Sheet: /
File: power_switch.kicad_sch

Title: Electronic power switch

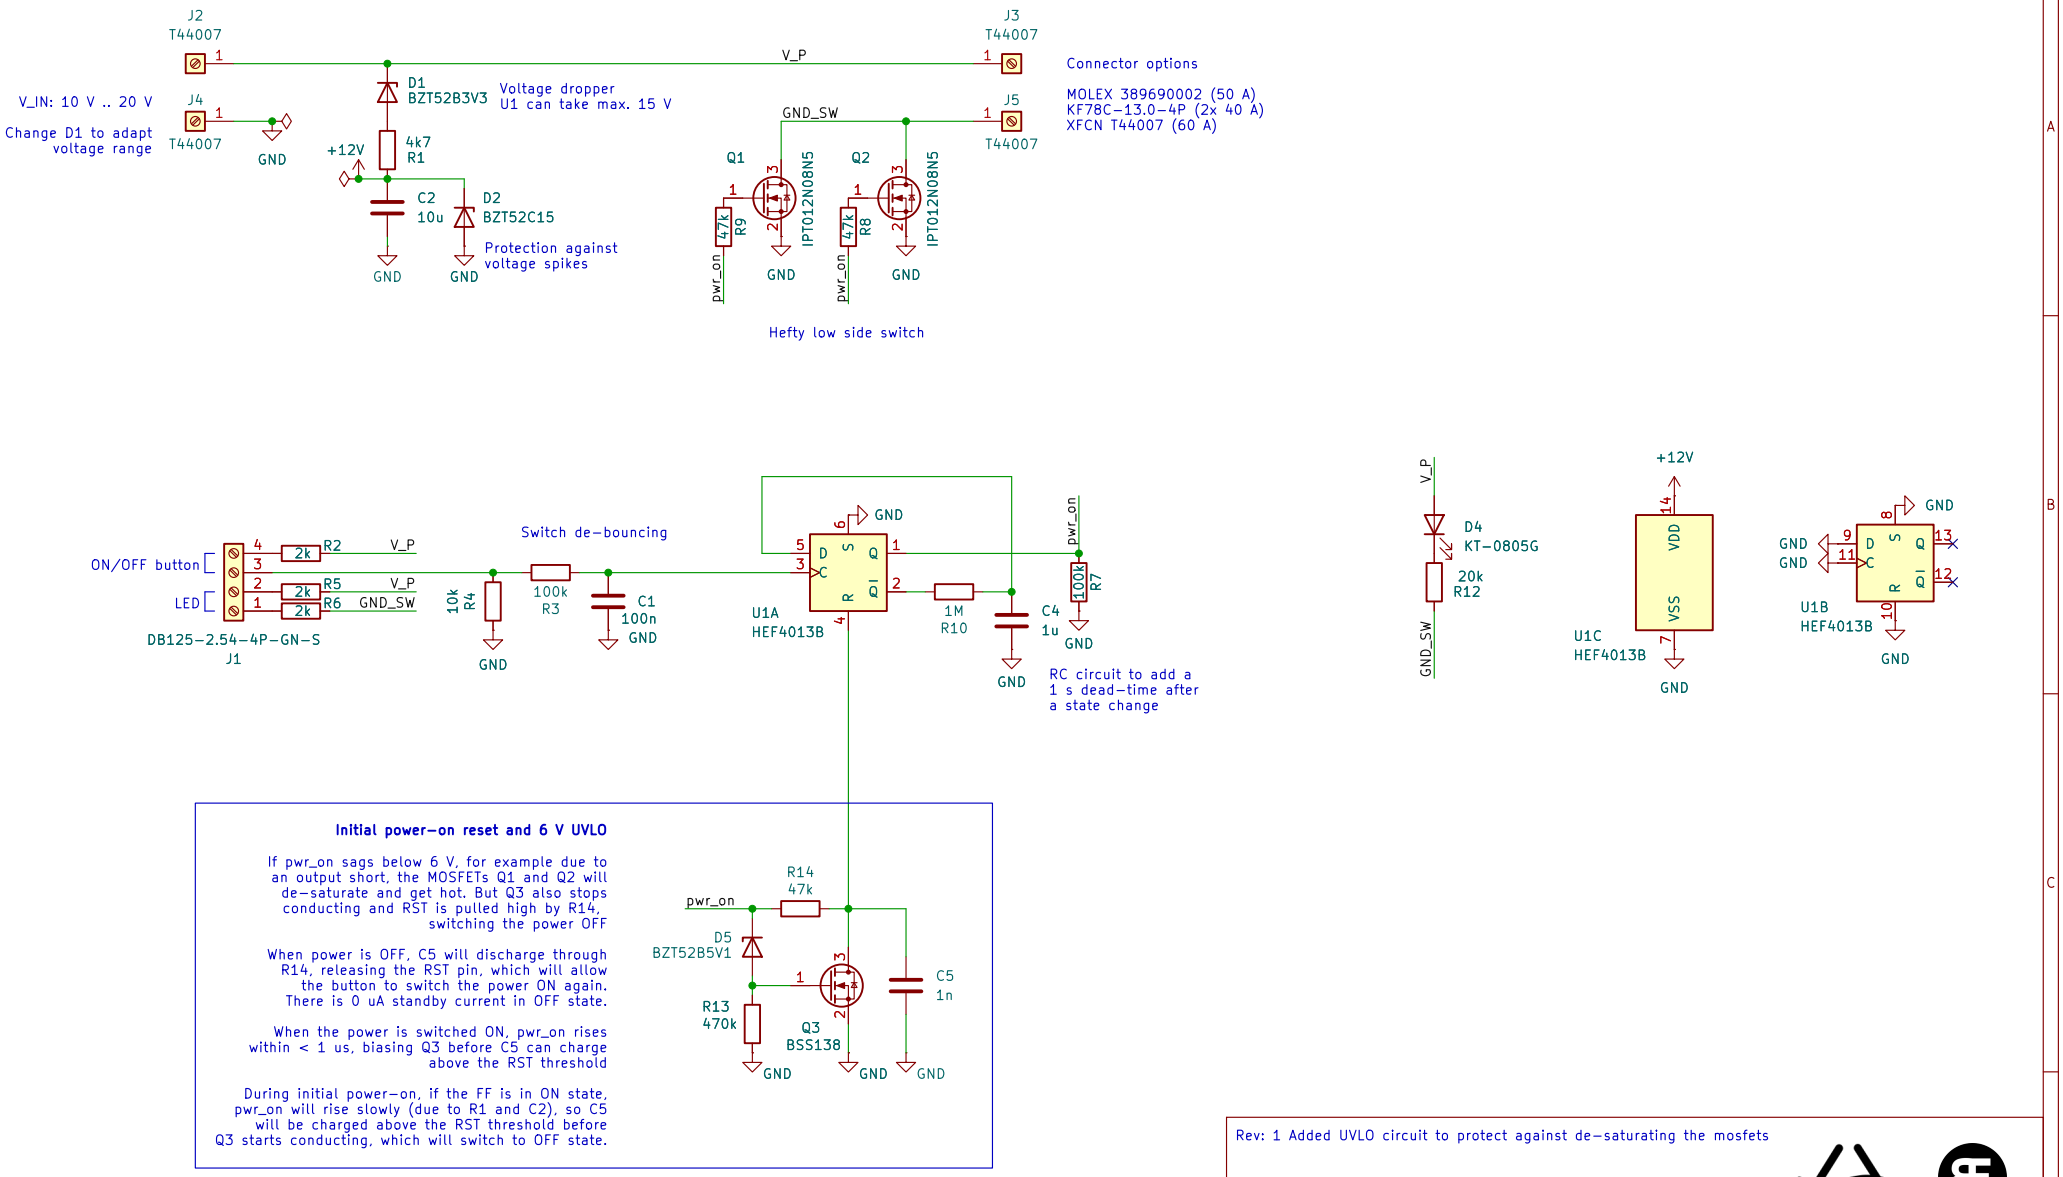
Rev: 1 Added UVLO circuit to protect against de-saturating the mosfets
